INDESIT company

Model type:
WE14SDE

Commercial code:
F027150

Notices

n1040231: Absent upper counter-weight

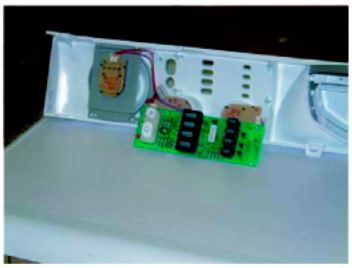
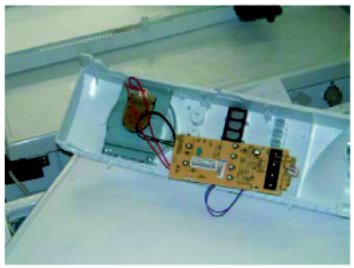
Our dishwashing machines have been designed with a static and dynamic balancing system to conform with the vibration, noise level, stability and reliability specifications.

In particular, the balancing has been obtained by the "balancing" mass, appropriately placed on the oscillating group. This balancing mass is made for:

Machines with spin cycle speed lower than 1400 rpm, by a frontal and an upper counter-weight in reinforced cement;

Machines with spin cycle speed equal or faster than 1400 rpm, by a frontal counter-weight in reinforced cement and by a cast iron universal joint spider (a red cross shaped component with 4 spokes, that in this range of washing machines fulfils both the structural and balancing functions);

FIG. 1

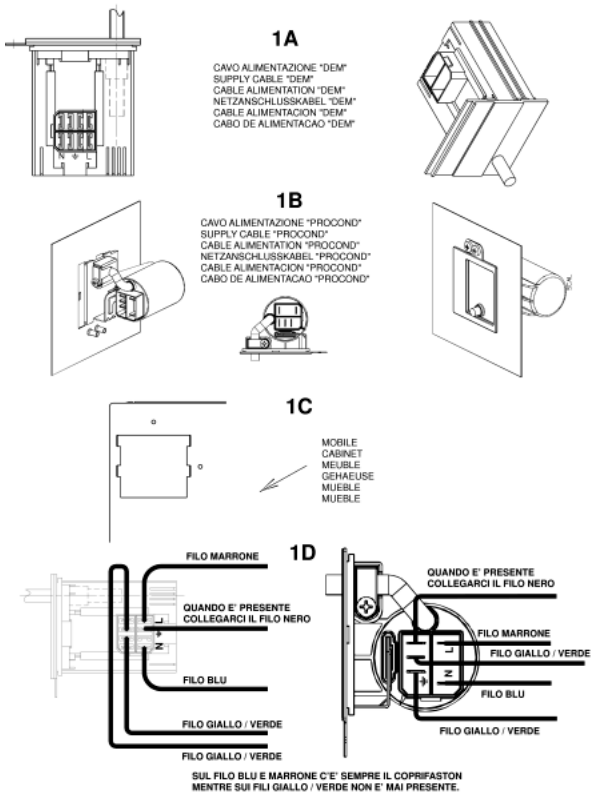
n1040276: Power supply cable + integrally moulded filter.

All appliances produced in the Comunanza (from serial no. 21008.0001), Teverola (from serial no. 21111.0001) and Brembate

(from serial no. 21119.0001) factories have been equipped with power supply cables with integrally moulded filter (see fig.1 - 1A and 1B) and new units having a specific opening at the back for fixing the new cables (see fig. 1 - 1C).
The new units, together with the new cables, can be used in place of the premodification ones, by connecting the wiring to the cable, as shown in figure 1 - 1D.
The codes of the new units and of those replaced (ESI - table n1040276fig02), which will be managed until stocks run out, are given below.

IMPORTANT: the fixing / continuity screw is a specific self-scraping screw (code 092348) that ensures earth continuity between the filter and the unit. The same screw must be refitted in order to guarantee machine conformity.

The premodification wirings, are also managed for modified products by making the connection to the terminal block of the new cable as shown in fig. 1 - 1D.
The wiring diagrams given in the Documentation remain unchanged.

The new power supply cables are:
Code 091632 - Power supply cable 3x1 schuko 1.5m+capacitance filter;
Code 091633 - Power supply cable 3x1 schuko 1.5m+inductive filter;
Code 091634 - Power supply cable UK 3x1 l= 1950mm + inductive filter;
Code 091635 - Power supply cable UK 3x1 l=1950mm+capacitance filter;
Code 091636 - Power supply cable l=2.55m AUS+inductive filter;
Code 091641 - Power supply cable l=2550mm AG +capacitance filter;
Code 091642 - Power supply cable 1.85mt SHUKO no inductive filter;
Code 091643 - Power supply cable 3x1 (CH) 1.5m+inductive filter;
Code 091645 - Power supply cable 3450mm SOUTH AF.+capacitance filter;
Code 091690 - Power supply cable shuko l2.55m KOREA+inductive filter;
Code 091689 - Power Supply cable l=2550mm AG+inductive filter.

n1040282: New drainage OKO system.

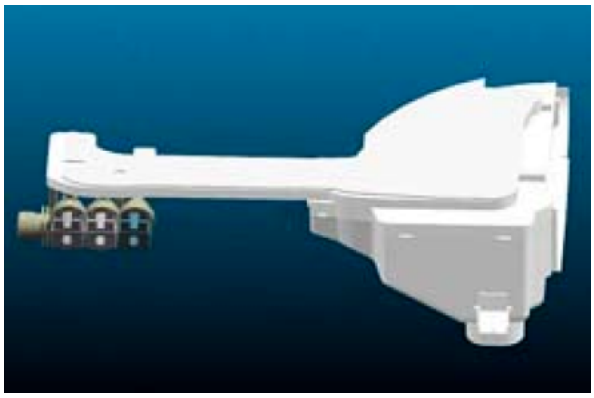
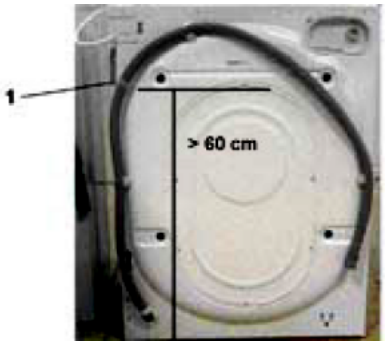
From serial number 21219.0001, the new "OKO" drainage system has been introduced on the washing machines produced in the Comunanza factory.

The new items are:

- EEPROM (the OKO system requires a new setting of load timing parameters). THE NEW EEPROMS REPLACE ALL THE ONES CODED PREVIOUSLY.
- BOWL (hopper tube hole shifted forwards);
- DETERGENT LOADING TUBE (see fig. 1);
- PRESSURE SWITCH (changed levels);
- OKO PUMP BOWL BLOWER + BALL (see fig. 2A, 2B and 2C);
- CONDUCTIVITY SENSOR (if provided, it is shorter than the premodification item);
- DRAIN PUMP (without detergent collecting tube connection);
- HOPPER (shifted in front of detergent loading tube connection). Fig. 3A post-modification. Fig. 3B premodification);
- AIR TRAP (different shape);
- PRESSURE SWITCH TUBE (different length);
- DRAIN TUBE STOP (specific);

In particular, the OKO system consists of a spherical plastic component inserted in the tube that connects the bowl to the drain pump (see fig.2 A).
At the beginning of each wash cycle the washing machine fills water for 10 seconds and activates the drain pump for 2 seconds. In this way, the water level in the bowl is different from that in the drain tube; this difference increases the thrust of the ball upwards, closing the bowl-pump connection tube hermetically (see fig. 2D).
This system has the double advantage of:

1) separating the wash water and the water in the drain hose, thus saving energy during the heating phase;
2) and ensuring optimal use of all the detergent.
With the introduction of this new component, the detergent collecting tube is no longer required and the pump has one hole only to convey water from the tank.
For the correct operation of the OKO system, it is important that the drain hose of the washing machine remains fixed to the back of the unit with a plastic clamp (to this end, the clamp withstands a 25 kg load; see reference 1 in fig. 4); otherwise, the drain hose must absolutely reach the height of the clamp. (minimum 60 cm.)
